**Report of the ATN Panel 7th WG2 Meeting
South Brisbane, Australia, 5th - 9th February 1996**

AERONAUTICAL TELECOMMUNICATIONS NETWORK PANEL

ATN Internet Working Group 2 (WG2)
Seventh Meeting Report

Figure 1: Present Encoding of Security Label

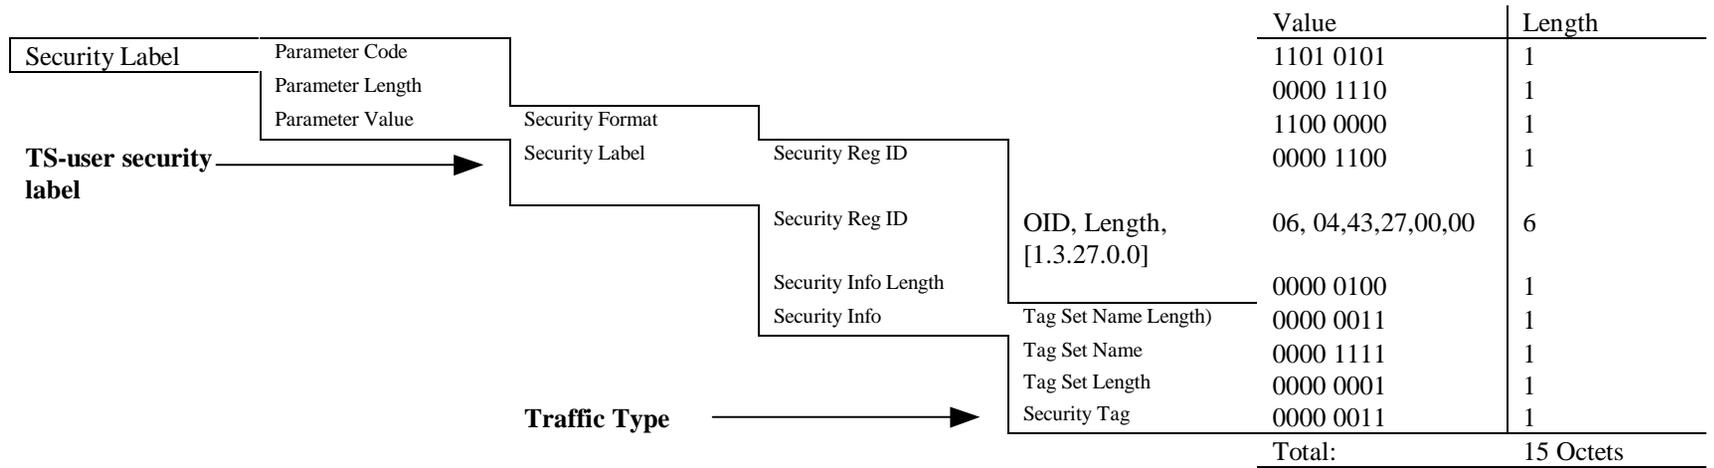
WG3 understands that the 13 octets labeled TS-user security label in Figure 1 are required to encode the one-octet Traffic Type.

forward compatibility to a known CNS/ATM-2 schema. [This is WG2 action 7-44 to draft a change request]

Recommendation WG3 recommends that WG2 incorporate the contents of the attached WG3 Flimsy in 2.7.1.1b, Table 2-2. WG3 notes that the traffic types have been extended to A-J. [This a WG2 action 7-45 is for WG3 to provide the approved table based on the material from the ADSP WG meeting in Dakar.]
